Hornsea Project Four: Consultation Report

Volume B1, Annex 1.27: Targeted Statutory Consultation under Section 42 of the Planning Act 2008

Hornsea Project Four Offshore Wind Farm– Adoption of an alternative Export Cable Corridor (ECC) route option at Lockington Carr Cross, Minor Onshore Route Amendments and additional Operational Access Rights

Hornsea Project Four Offshore Wind Farm– an alternative export cable corridor (ECC) option at Lockington Carr Cross, minor onshore route amendments and additional operation accesses

Supporting documentation – Map 1 – S42 targeted statutory consultation [1] minor changes overview map

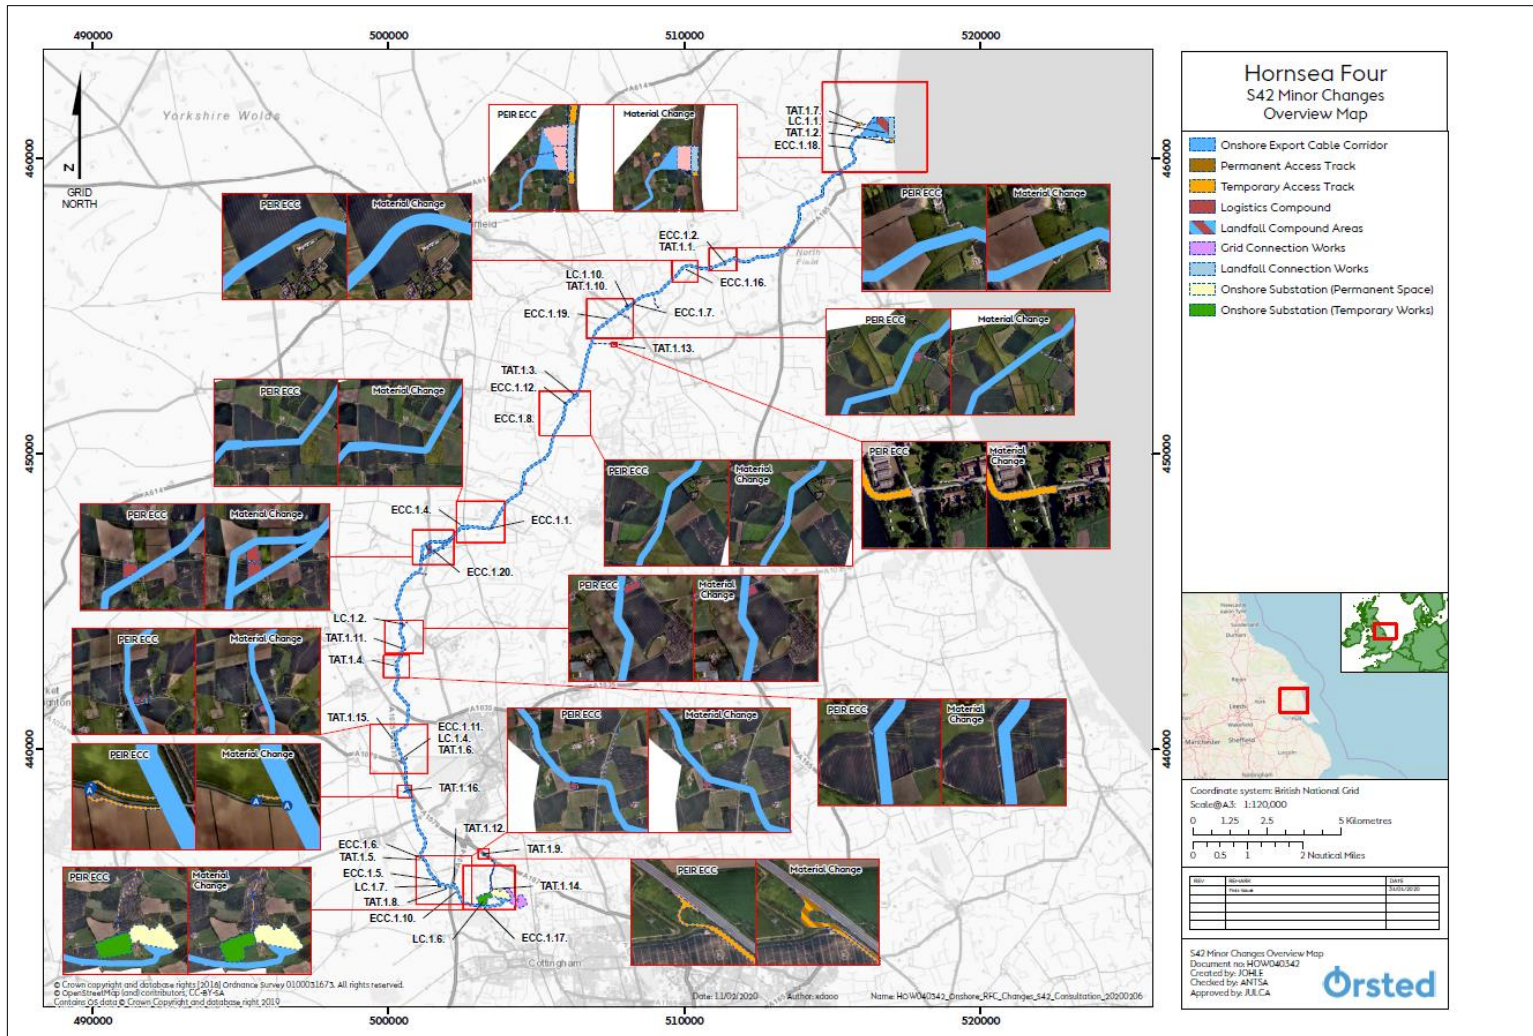
In response to comments received during the Statutory Consultation and subsequent discussions with landowners and occupiers, Hornsea Four is seeking comments on an alternative cable corridor routing option (Option B) at Lockington Carr Cross which is located to the north and west of the proposed cable corridor shown in the Statutory Consultation on the PEIR at this location (Option A). The alternative cable corridor routing option (Option B) is 1,385 m long and 80m wide. The construction would be as per Option A. Please note that Hornsea Four continues to consider both Option A and Option B in this location.

In response to comments received during the Statutory Consultation and ongoing design development, Hornsea Four is proposing 36 minor amendments to the onshore ECC shown at PEIR. These comprise:

- 14 amendments to the onshore ECC route
- 6 amendments to the logistic compounds
- 16 amendments to temporary access tracks

Supporting documentation – Map 3 – Overview of operational accesses

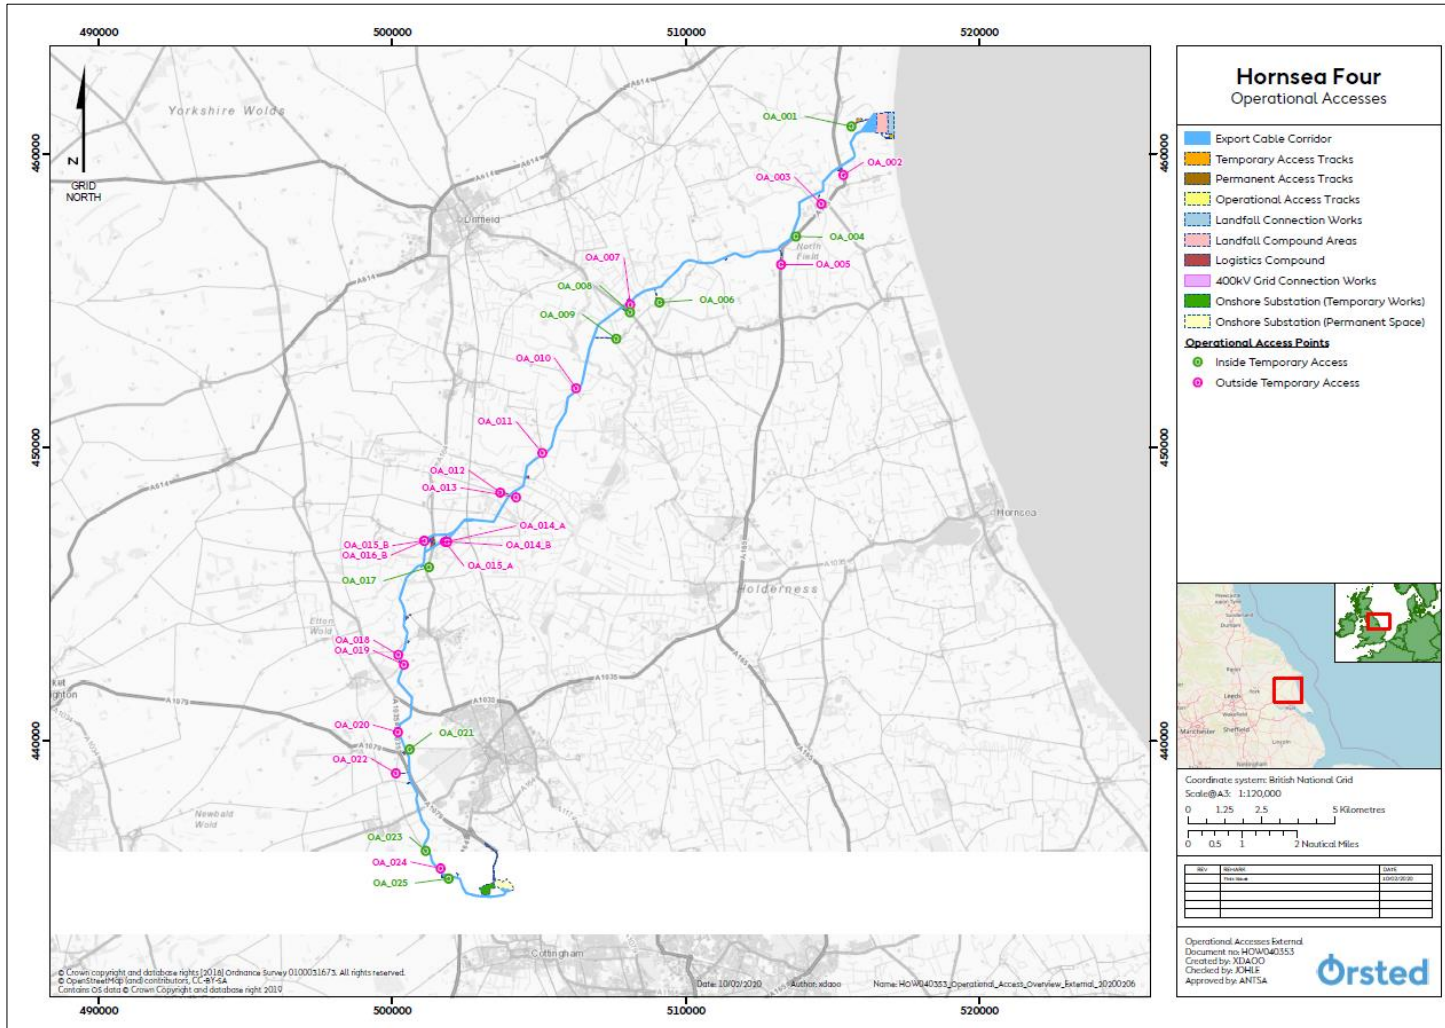
In this Targeted Consultation Hornsea Four is requesting comments on the proposed use of 27 new operational accesses (including 9 accesses which were previously identified as only temporary construction accesses in the Statutory Consultation on the PEIR (see Inside Temporary Access ID on **Map 3**) and 18 new operational accesses using existing farm accesses (see Outside Temporary Access ID on **Map 3**) to gain access to the link boxes and cables during the operational phase for maintenance purposes.

Should the applicant progress with Option A there would be 24 accesses in total taken forward to construction and operation, comprising 9 accesses previously identified as temporary construction accesses and 15 new operational accesses.

Should the applicant progress with Option B would result in 25 accesses in total taken forward to construction and operation, comprising 9 accesses previously identified as temporary construction accesses and 16 new operational accesses.

Hornsea Four S42 onshore substation overview map

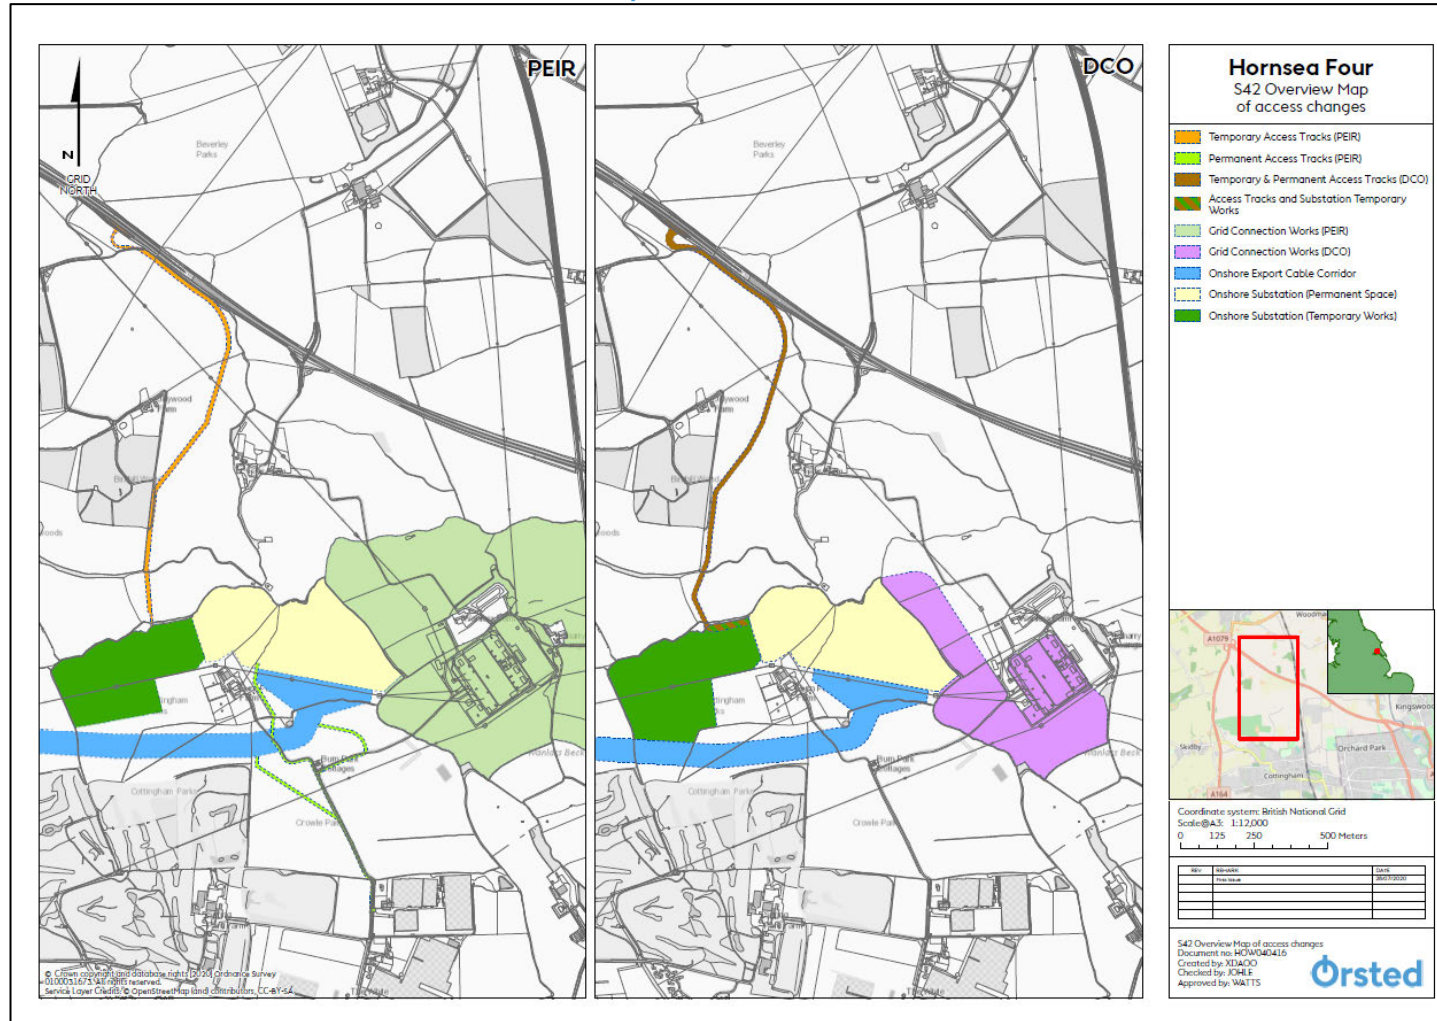
The potential for the temporary onshore substation and energy balancing infrastructure construction access to become a permanent operational and maintenance access was initially identified within the PEIR (Volume 1, Chapter 3: Site Selection and Consideration of Alternatives and Volume 1, Chapter 4: Project Description). In response to a number of consultation responses received from local residents, parish councils and engagement with the local highway authority, Hornsea Four now proposes that an access track will remain in situ for the lifetime of the offshore wind farm, removing the requirement to route vehicles from the south, through Cottingham.

Hornsea Four S42 access change overview map

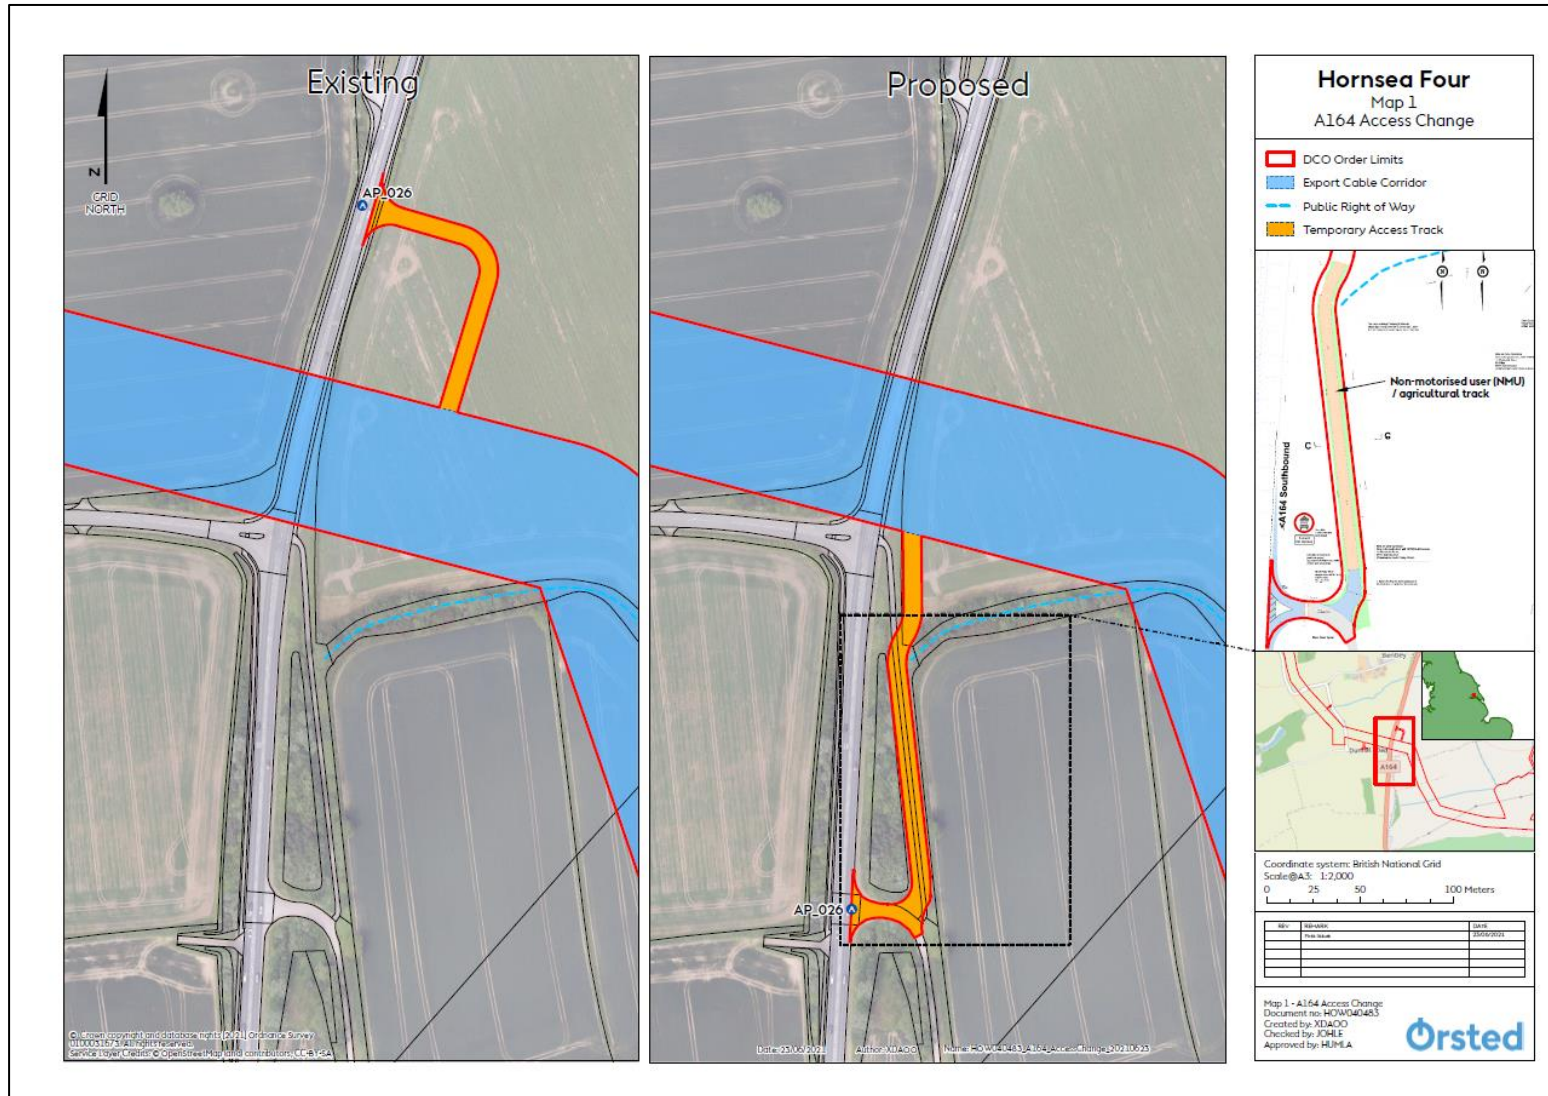
- Due to the amended highways layout, the Hornsea Four existing construction access would require significantly more engineering and construction works than anticipated. These works would include on and off ramps to provide a safe highways arrangement to facilitate the construction of Hornsea Four and the continued use of the A164; and
- The proposed non-motorised user (NMU) / agricultural track (consented as part of the Jock's Lodge Scheme) that will run adjacent to the A164 (as shown on **Map 1**) would need to be diverted if the existing Hornsea Four construction access was progressed. The diversion would be required to provide a safe crossing location, set back from the A164, to allow Hornsea Four construction vehicles to safely turn off the A164, with sufficient space / visibility prior to crossing the NMU / agricultural track.

Comment	Project change? (Y/N/I or N/A) ¹	Project commitment? ² (Io/New/N/A)	Applicant response
<p>Lazaat Hotel requested a more detailed map and further information on the access change prior to confirming no objections to the proposals.</p>	N/A	N/A	<p>The Applicant provided an additional map and Andy Acum, Community Liaison Officer, met to answer any questions.</p>
<p>The move south for construction traffic access, under the circumstances of Jocks Lodge Scheme, seems sensible.</p> <p>My only concern, as part of the Beverley Ramblers Team involved in prior consultations with you at Cottingham, is continued access for walkers travelling north, from the south using the non-motorised/agricultural 'old road'. This is important for access to the Jillywoods Lane Public Right of Way (Skidby Footpath 12) thereby allowing walkers access to other routes to the east of Jillywoods Lane running north/south. Jillywoods Lane footpath is an important link route allowing excellent, popular circular walks from the Beverley and Cottingham areas.</p> <p>It is noted in your cover letter under 'Proposed Change' that, 'construction traffic volume is anticipated to be low in this location'. Could you please confirm access to the above PROW will still be available whilst also used for construction access?</p>	N/A	N/A	<p>Comments regarding the validity of the access change and general support of efforts to encourage the cooperation and interaction between the two projects is noted.</p> <p>The Applicant can confirm that appropriate management measures will be developed, through consultation with East Riding Yorkshire Council, to minimise disruption to the Non-motorised User Route (NMUR). General detail is provided in the Outline Public Right of Way Management Plan, which forms Appendix C of Volume F2, Chapter 2: Outline Code of Construction Practice, which will provide the basis of the detailed Code of Construction Practice.</p> <p>The Applicant will work with ERYC pre-construction and during construction to ensure the NMUR remains open when possible. This will involve the use of management measures to facilitate construction traffic and users of the NMUR itself. It is acknowledged that during the construction of the construction access road, and peak</p>

<p>We note that the Jock's Lodge development and the Hornsea 4 project are going ahead in close proximity, and we appreciate that you are attempting to avoid disruption to public access as far as possible.</p>			
<p>Skidby Parish Council raised no objections to the proposals</p>	N/A	N/A	The Applicant notes this comment.
<p>From the information detailed on the plan KCOM has apparatus the area of your works and could be affected by it. KCOM attached a plan showing details of the areas which may be affected by your potential works. If the works go ahead and more detail is given to the construction of the entrance and access road leading to the site we can forward a C3 budget estimate for any diversionary works we need to carry out</p>	N/A	N/A	The Applicant and KCOM have worked together to agree Protective Provisions in respect of the Hornsea Project Four works. Once detailed designs are completed the Applicant will provide KCOM drawings to ascertain whether diversionary works are required. Upon determination, the Applicant will continue work with KCOM to ensure that a mutually satisfactory solution is put in place
